Project:	Highways England Spatial Planning Arrangement 2016-2020	Job No:	60600479/ DF006.001
Subject:	Aquind Interconnector – Initial Review of Documentation		
Prepared by:	Senthi Sivanathan	Date:	15th January 2020
Checked by:	Andrew Cuthbert	Date:	17th January 2020
Verified by:	Kelly Davis	Date:	20th January 2020
Approved by:	Andrew Cuthbert	Date:	22nd January 2020

- 1.1. On behalf of Highways England, this Technical Note (TN) documents AECOM's initial review of the 'Traffic & Transport' chapter of the Environmental Statement (ES) for the proposed Aquind Interconnector. These documents have been accessed from the Planning Inspectorate (PINS) website as part of the documentation accompanying an application for a Development Consent Order (DCO) with PINS Reference: EN020022.

Figure 1: Junctions in the Study Area
(Source: SRTM DAR Appendix B)

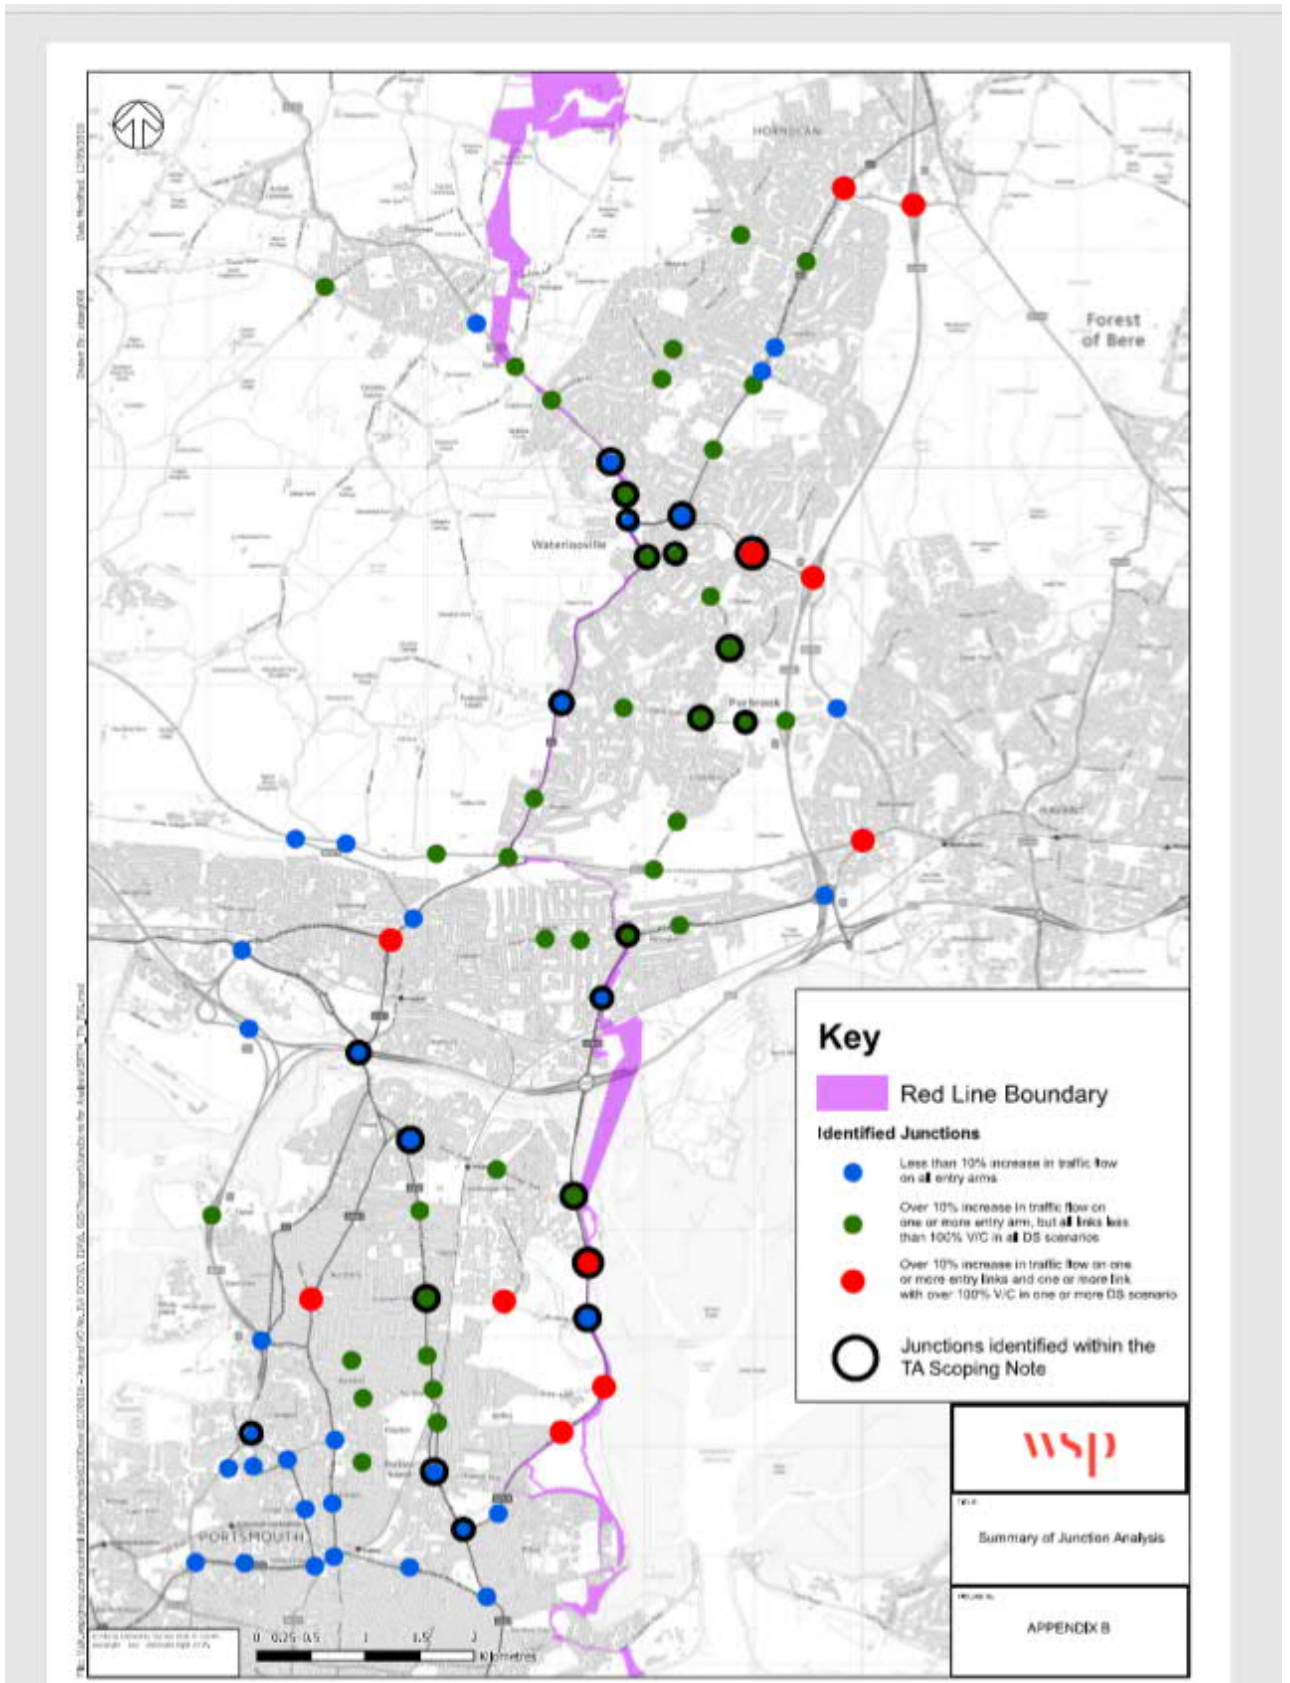
- 1.11. With the exception of the A27/ A2030 junction (which AECOM has previously recommended should be included), these locations were illustrated on the figure at Appendix B of the SRTM DAR, a copy of which is reproduced at Figure 1 on the following page.
